INCREASED CAPACITY SPENT FUEL RACKS
NO. 1 UNIT
SALEM NUCLEAR GENERATING STATION
DOCKET NO. 50-272

Public Service Electric and Gas Company hereby submits additional information in support of its application to increase the spent fuel storage capacity at the Salem Nuclear Generating Station. This information is in response to discussions held with members of your staff.

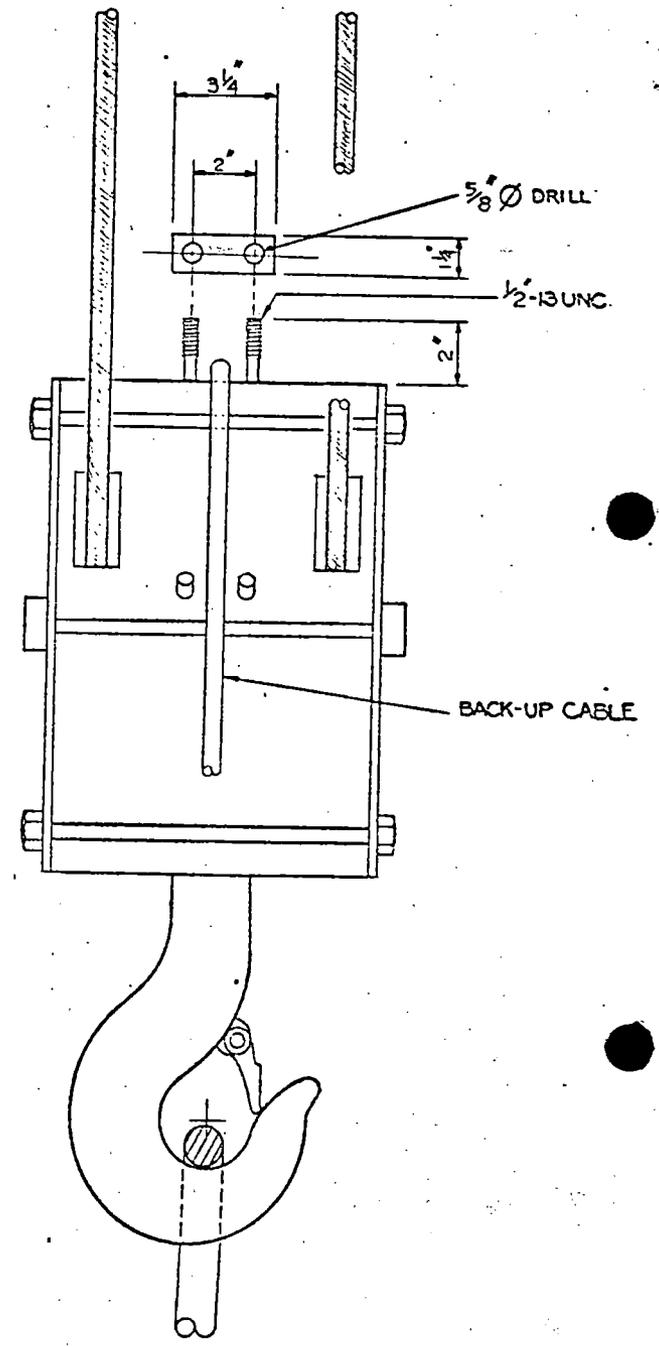
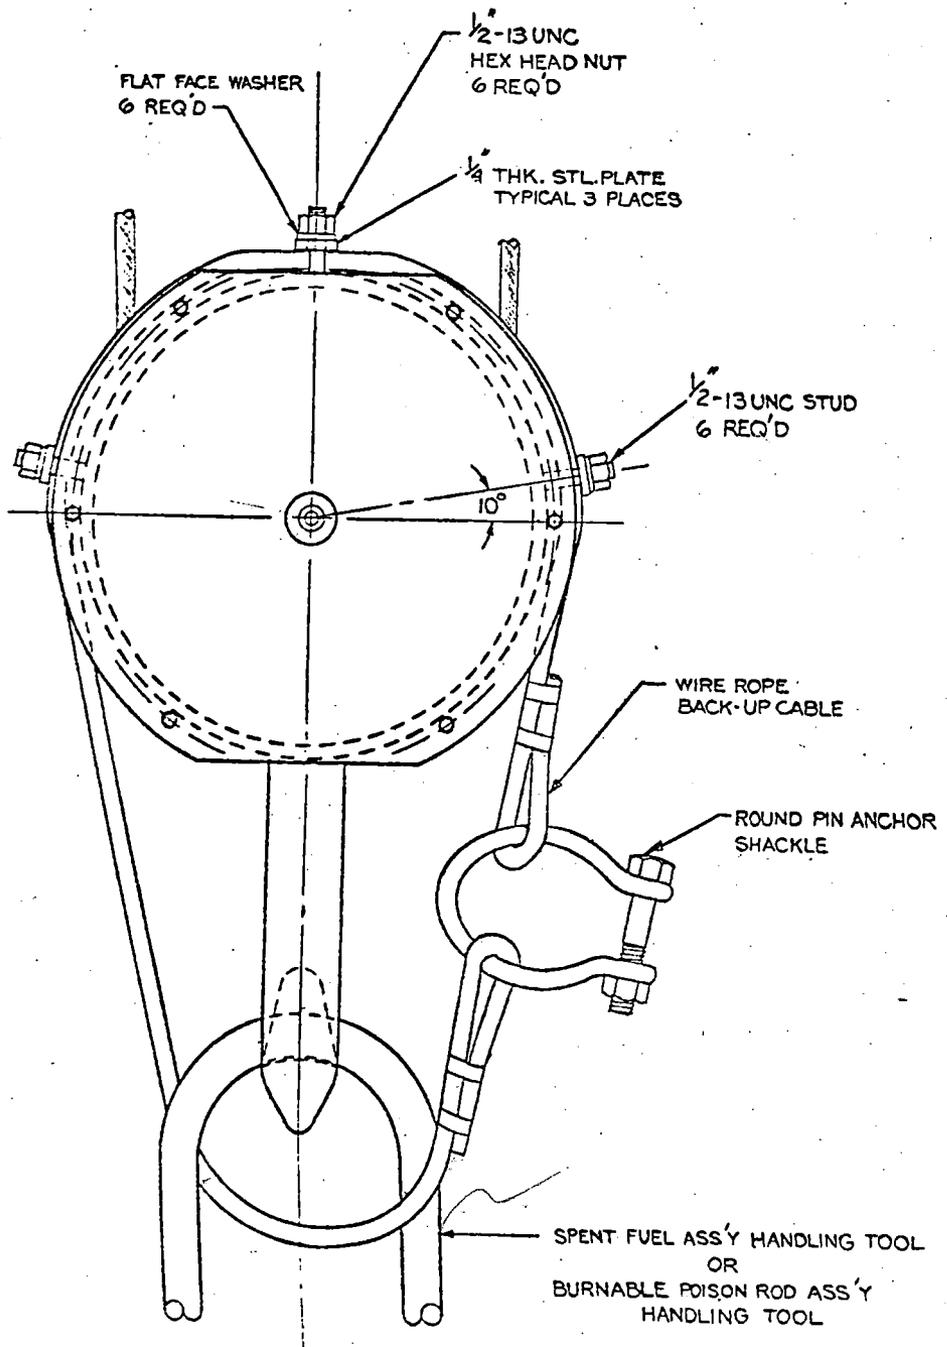
Verify that the racks will withstand the drop from the maximum transport height of any of the items which will be carried over the racks when impacting the racks both horizontally and vertically, without violating the appropriate acceptance criteria. In addition, discuss the effects of the total rack structure flexibility on the results of the postulated drop analyses.

To provide yet another redundant safety feature, a back-up cable will be attached to the tools. This feature consists of an attachment around the load block and around the supporting area of the tool. Should the tool weight be transferred from the hook to the cable, the load would be transferred to the block and thus back into the normal reeving and sheave assemblies; deformation of the block housing, should it occur in a tool drop accident, is considered acceptable as long as the back-up cable prevents the tool from dropping. The cable rating and design factors will be similar to those of the fuel handling crane. The attached drawing demonstrates the back-up cable.
